# Notice of Modification

## Section 75W of the *Environmental Planning and Assessment Act 1979*

The project approval (08\_0101) granted by the Minister for Planning on 26 November 2010 for the Integra Underground Project.

Figure 4: Approved Middle Liddell Seam - Longwall Panels (330 m width for Longwalls 15 – 19)

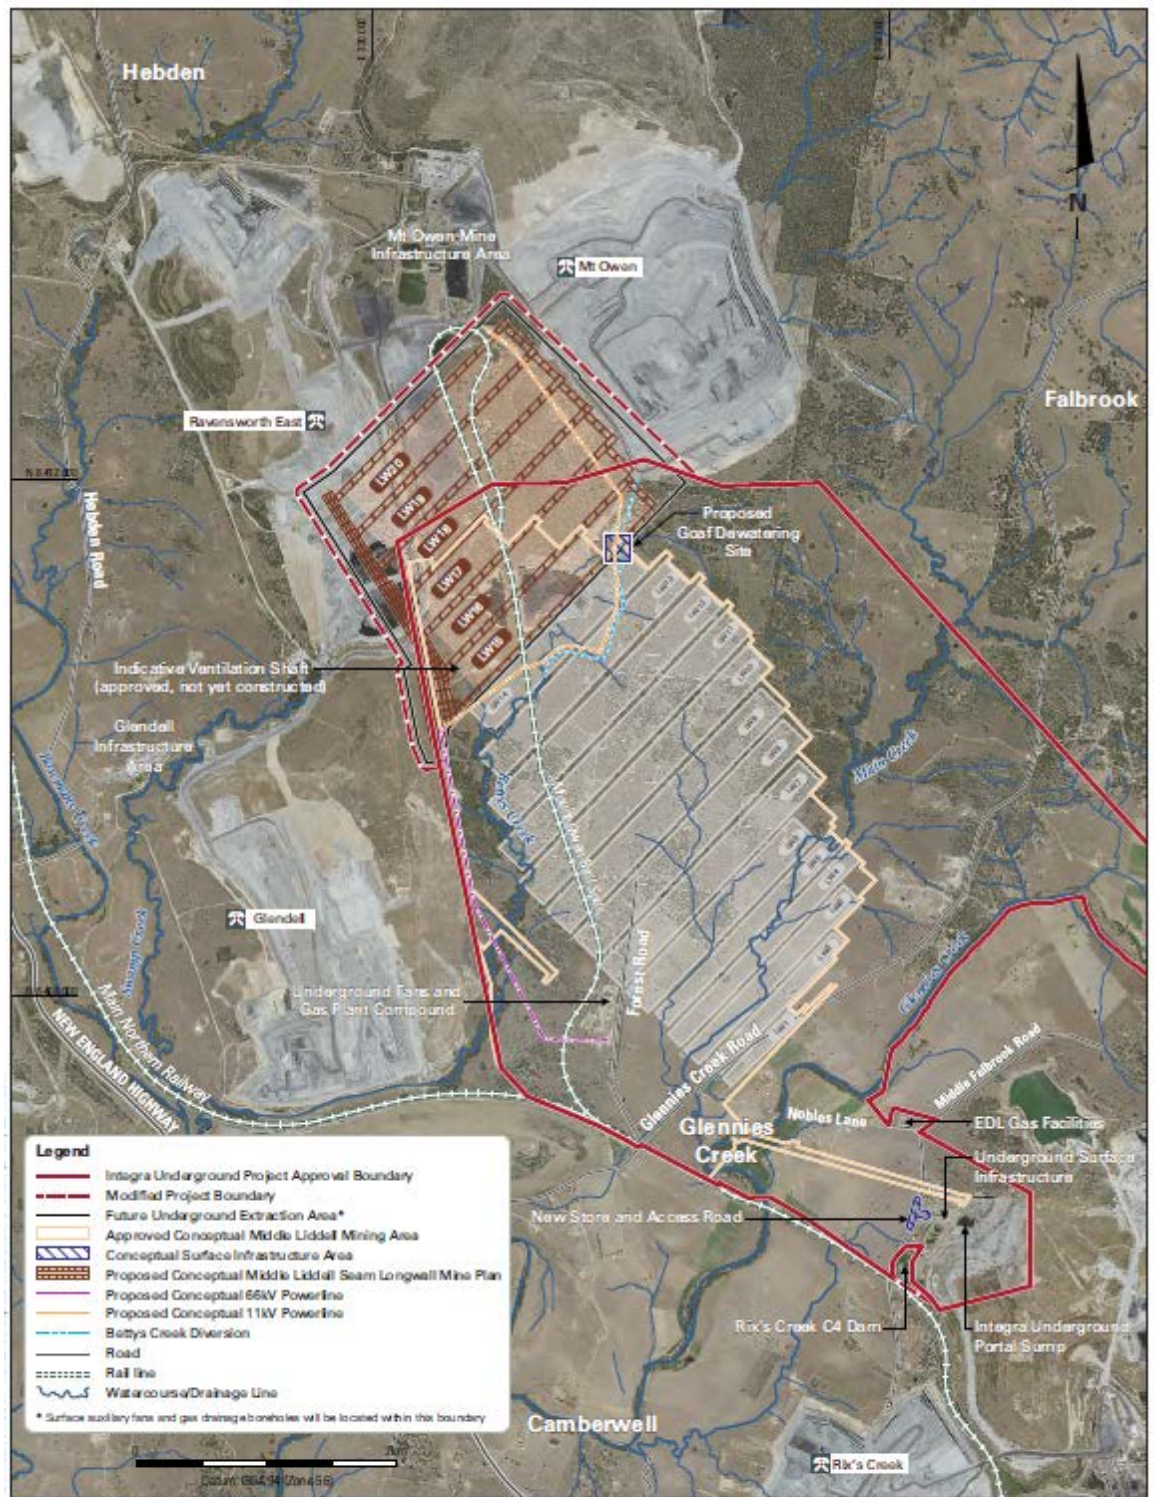
- 11. Delete Figure 2 in Appendix 3.
- 12. In Appendix 3, following Figure 3, insert the following:
